*Errata and Added Information to*  
**MC68360 Quad Integrated Communication  
Controller User's Manual Rev 1**

January 8, 1998

This document describes the latest information and changes to the first revision of the MC68360 user's manual.

**Figure 6-6A External Components for 4.192MHz**

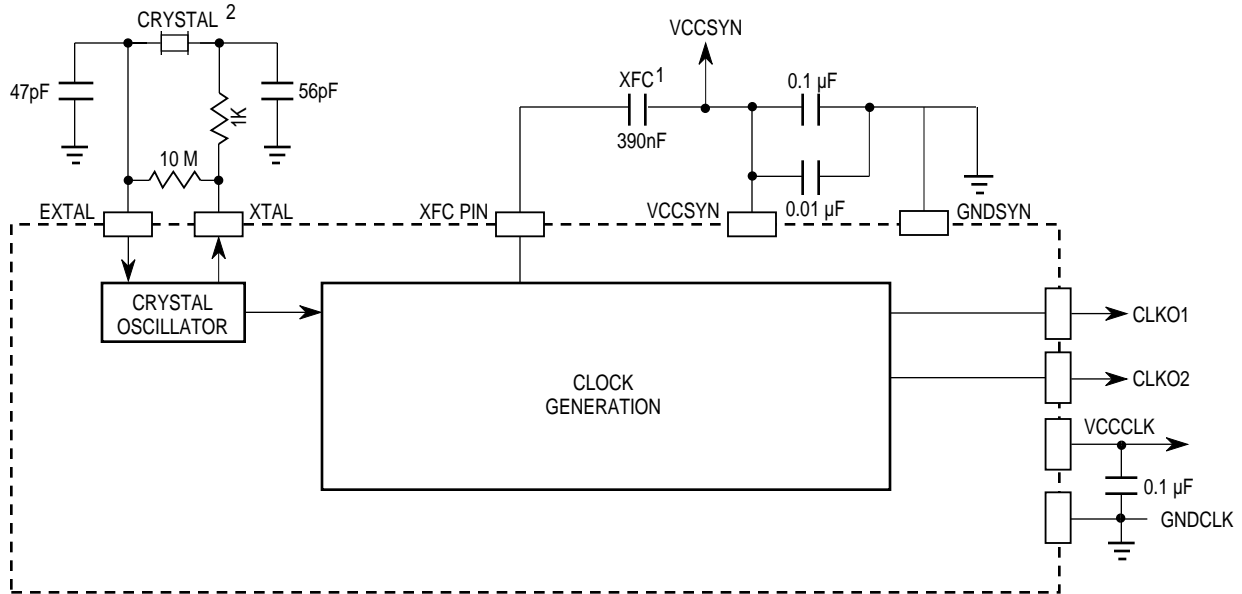
Also on page 6-14 the following figure should be added.

1. Must be low-leakage capacitor. See Section 10 Electrical Characteristics for recommended values.
2. Values are for 4.194MHz crystal and may vary due to capacitance on PCB.

**Figure 10-44(a). MC68040/EC040 SRAM Read Cycles (TSS40=0, CSNT40=1)**

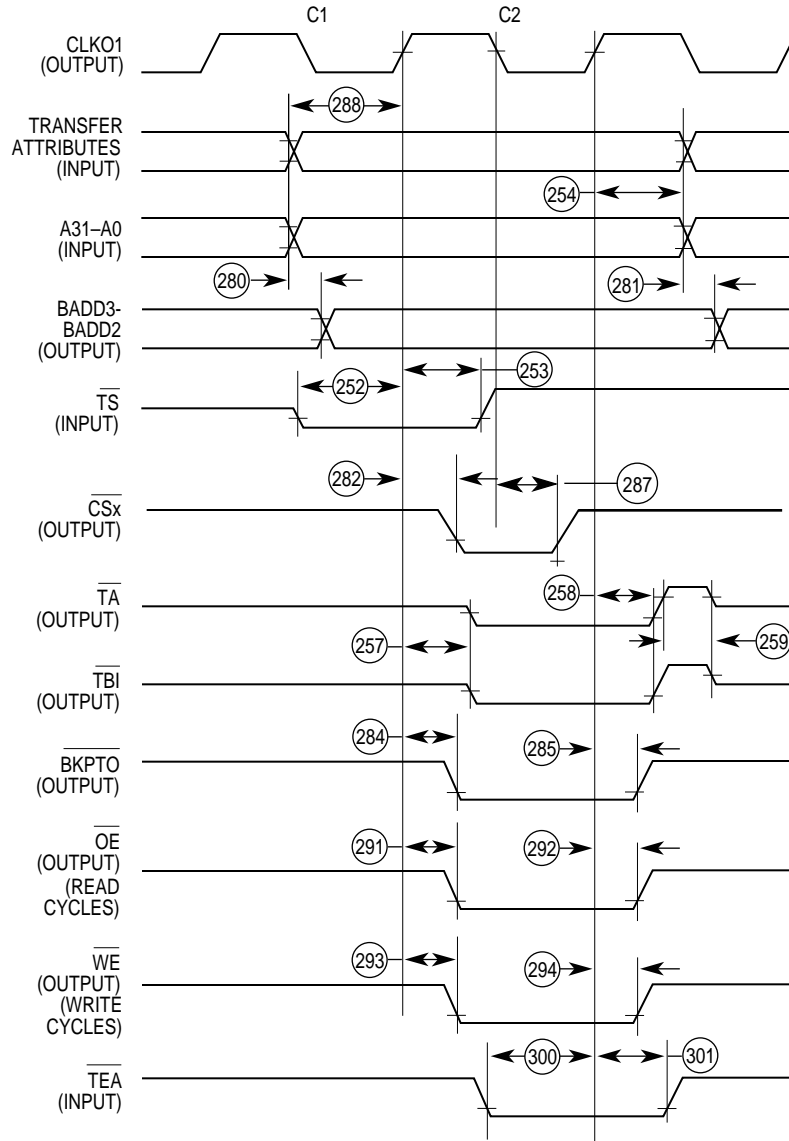
On page 10-57 the figure title should be replaced with the following

The following figure should be added after figure 10-44(a)

NOTE: MC68040 Transfer Attribute Signals = SIZx, TTx, TMx, R/W, LOCK

**Figure 10-44(b) MC68040/EC040 SRAM Write cycle (TSS40=0, CSNT40=1)**

**Figure 10-45(a) MC68040/MC68EC040 SRAM Write cycle (TSS40=1, CSNT40=1)**

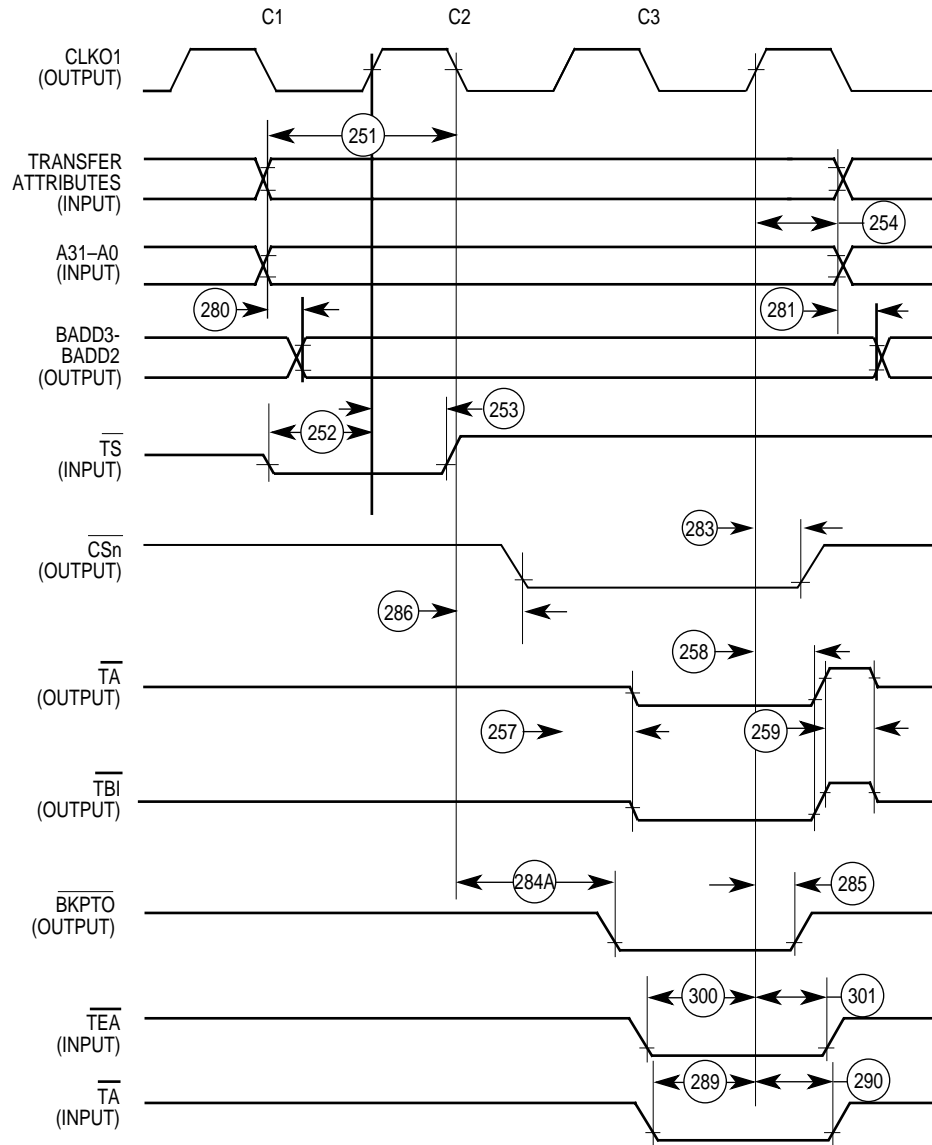
On page 10-58 the figure title for FIGURE 10-45 should be replaced with the following.

**NOTE**

$\overline{OE}$  and  $\overline{WE}$  signals are not supported when TSS40 is set to 1.

The following figure should be added below figure 10-45(a)

NOTE: MC68040 Transfer Attribute Signals = SIZx, TTx, TMx, R/W, LOCK  
OE and WE are not supported when TSS40 is set to 1

Figure 10-45(b) MC68040/EC040 SRAM Read Cycle (TSS40=1, CSNT40=1)
